TRANSMITTAL OF VARIANCES TO PROJECT SPECIFIC PLANS

VARIANCE / FIELD CHANGE NOTICE

Page 1 of 2PROJECT TITLE: PSP for Area 9 Phase I Pre-Certification Real-Time Scanning
(20702-PSP-0001), Revision 4Date: 3/8/99

This Variance documents the Revised Figure 1-1, which should be added as a change page to the PSP for A9PI Precertification Real-Time Scanning. The Figure was modified to show a small area north of the total uranium concentration that failed certification in A1PI (in CU O20). As discussed in the PSP, this area will be included in the Certification of A9PI, but not in precertification.

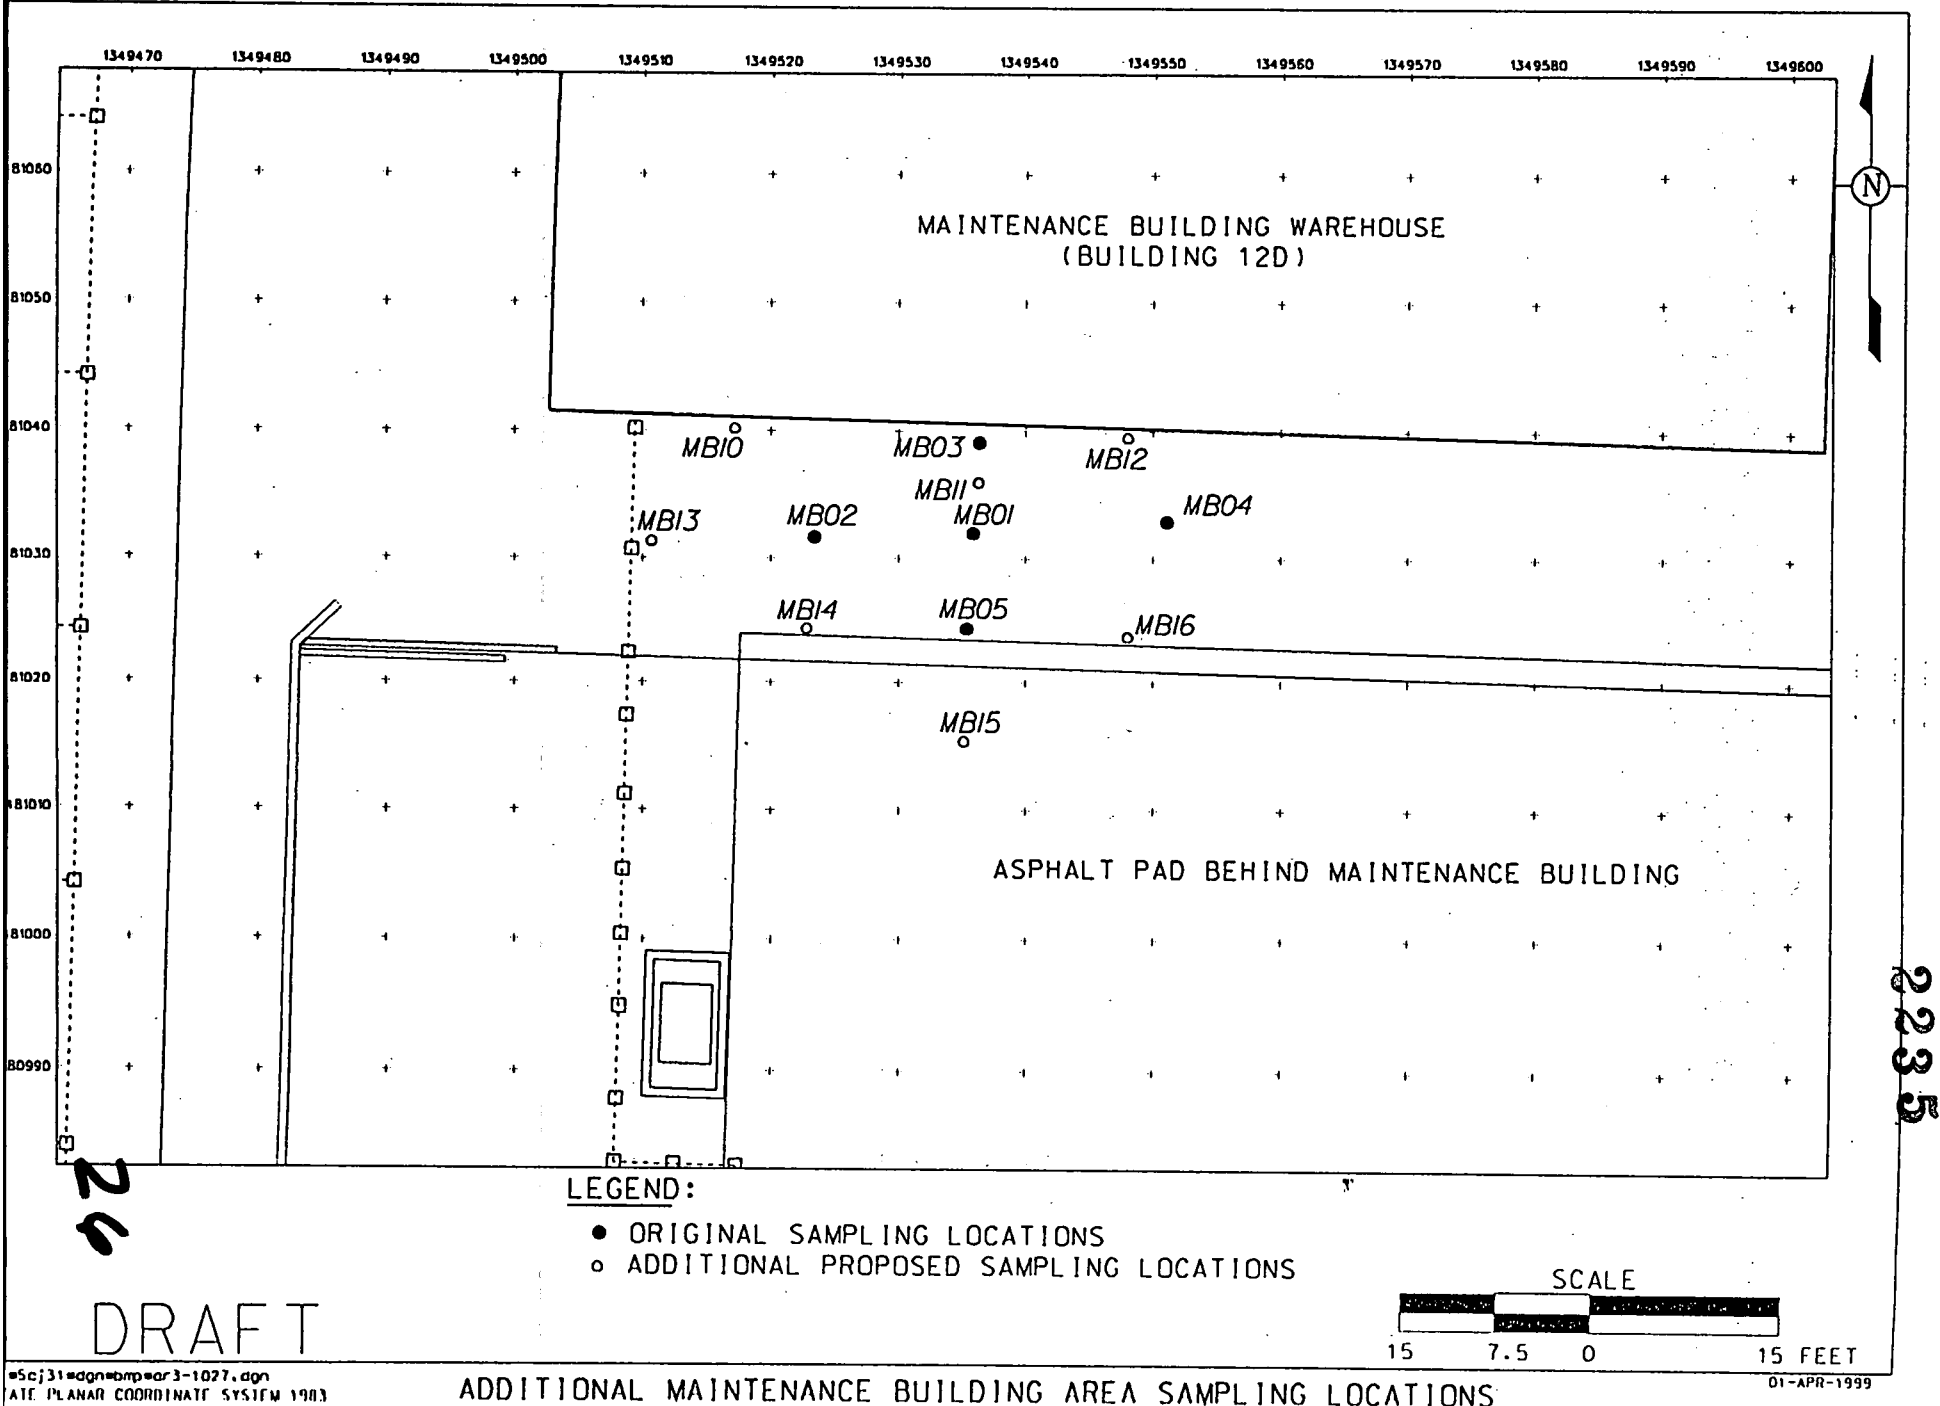
The attached figure illustrates the location of borings MB10 through MB16. The attached addendum to Appendix B of the PSP lists the northing and easting coordinates, sample intervals, and sample identification numbers for each of the additional borings.

TCLP analysis conducted under this PSP indicated that trichloroethene is present in the soil north of the Maintenance Building at levels that exceed the characteristic regulatory limit in borings MB01, MB02, MB03, and MB05. However, the initial investigation did not bound the limits of this hazardous soil in either the horizontal or vertical directions. The seven additional borings will surround the original borings with elevated levels of trichloroethene to the east, west, and south and will be advanced 3 feet deeper than the original borings. No additional borings are being conducted to the north of the contamination due to the location of the Maintenance Building Warehouse. Following D&D of that building, additional borings will be conducted to bound the contamination to the north.

Variance
20310-PSP-0001-1
pg 2 of 2
3/30/99
Real time Soil Scan
Former Coal Pile Area
A3A

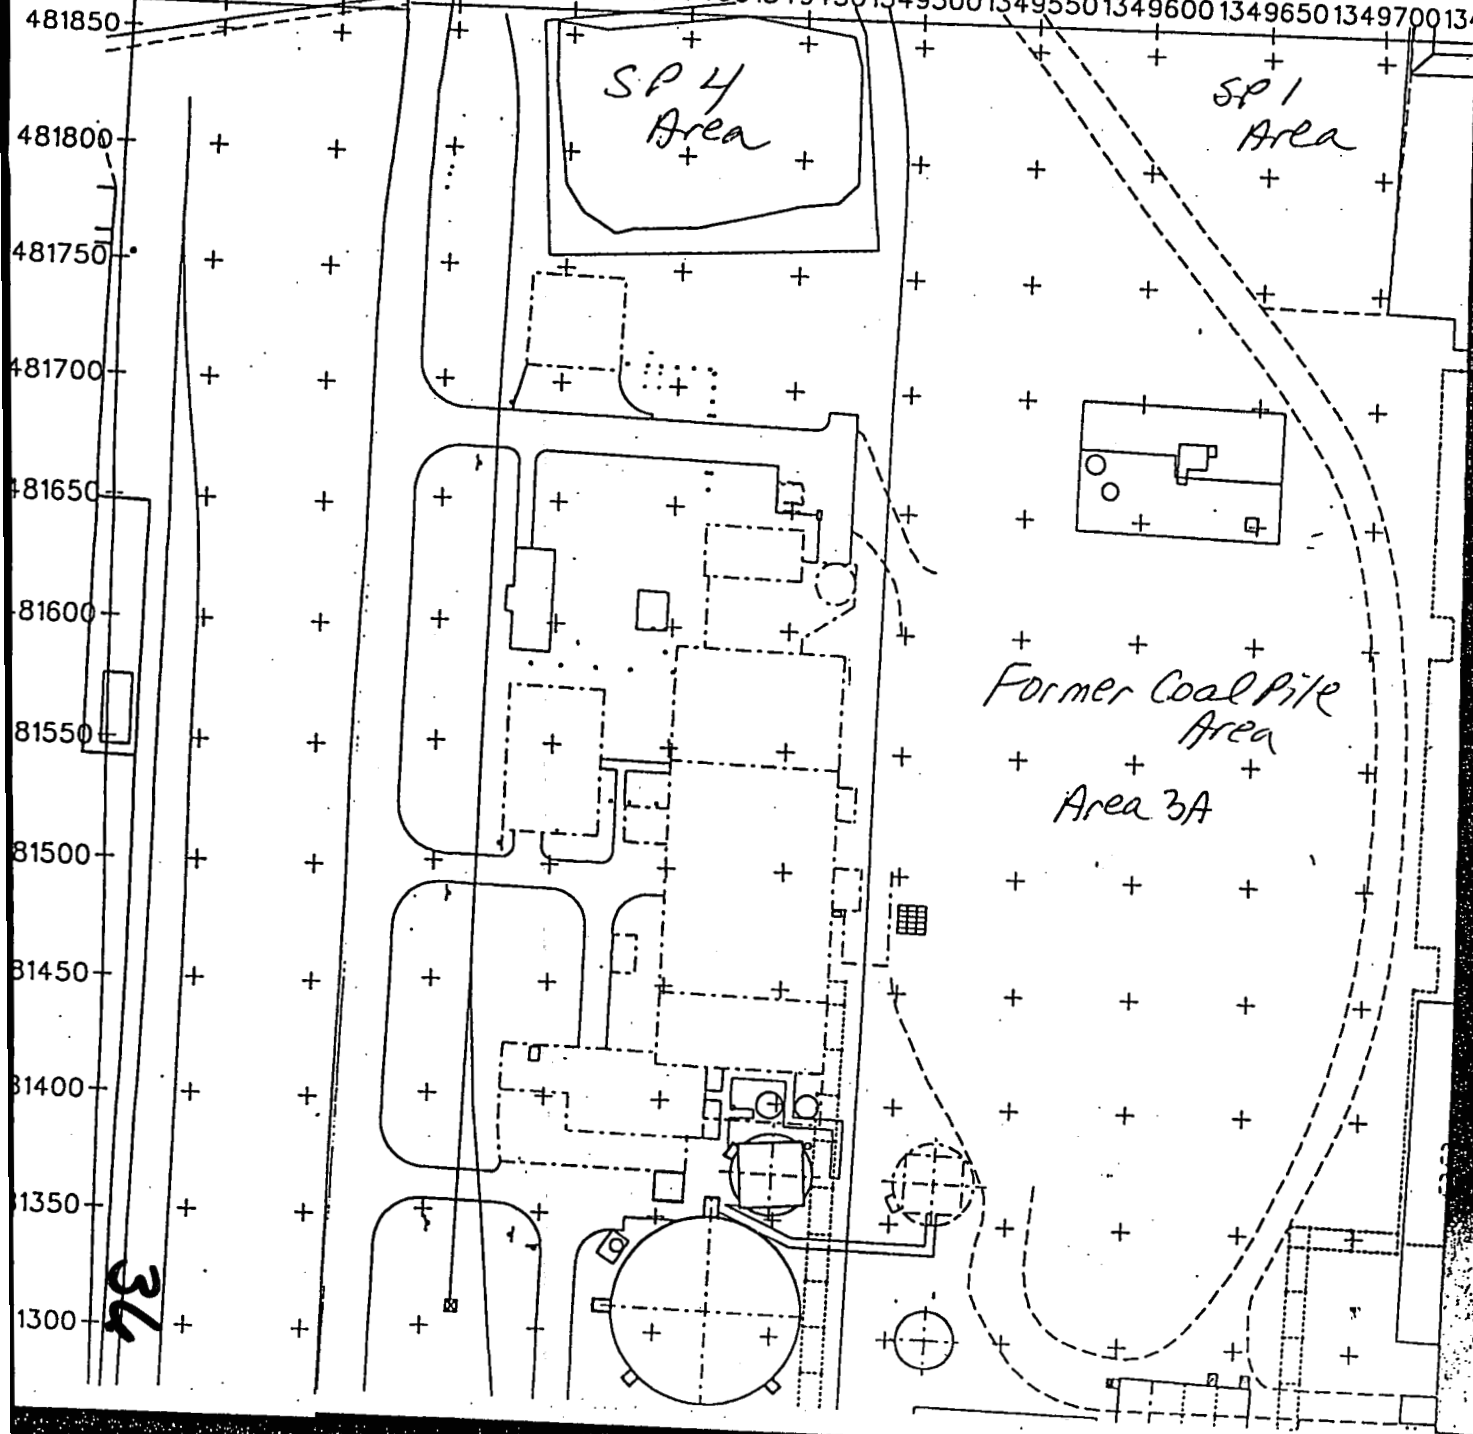
1 - Real-time surface soil characterization for potential WAC attainment is being performed under this variance on the soils in the footprint of the former Coal Pile area and the immediately surrounding area. This area is soon to become a construction lay-down area and will be inaccessible for WAC characterization for an undisclosed period of time. No Area 3 WAC attainment PSP is currently approved for this area (predesign is still in the planning stages), therefore this work will be performed under the RTIMP WAC Attainment Scanning in Miscellaneous Areas PSP. The area under investigation is shown on Page 2 of this variance.

2 - The RSS is to be used to collect data in the former Coal Pile area in A3A of the former process plant. The area extends from the south end of the former Coal Pile area to the Haul Road on the north end. The north end is bordered on the east by Soil Pile 1 and on the west by Soil Pile 4.
